**WOKINGHAM
BOROUGH COUNCIL**

Discharge of condition Consultation

Site Address: Land west of Kingfisher Grove, Three Mile Cross

(APP/X0360/W/22/3304042). Condition 7 relates to details of the construction of the access.

Refuse Vehicle:

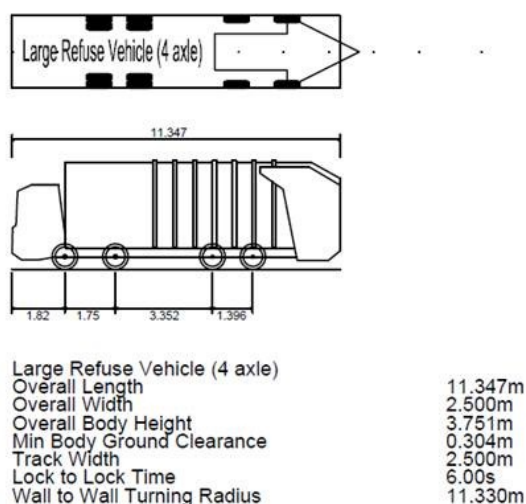
Paragraph 1.4.4 states that “Vehicle tracking confirms that a large refuse vehicle can enter and exit the site in forward gear”. This has not been provided. Vehicle tracking is to be submitted to show Refuse and Fire access into, circumnavigation of, and exit from site in the forward gear. The specifications for the design vehicles are provided below
